Airworthiness Directive Schedule

Bell 412 Series

24 June 2021

Figure 1 Fuselage tailboom attachment inspection

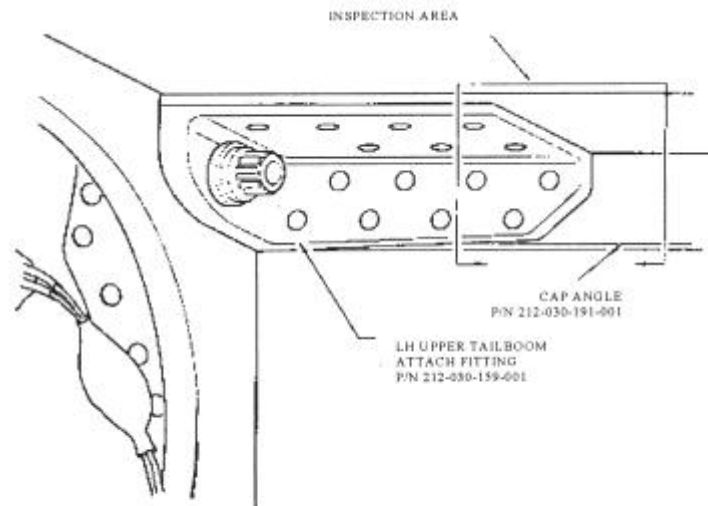
Requirement: To prevent failure of a cap angle, loss of the tailboom, and subsequent loss of control of the helicopter, inspect the cap angle and adjacent structure for a crack in the area shown in figure 1. Use a 10-power or higher magnifying glass. If a crack is found in the cap angle, replace it with an airworthy cap angle before further flight. Repair any crack found in the adjacent structure before further flight.

Compliance: Within 25 hours TIS and thereafter at intervals not to exceed 100 hours TIS.
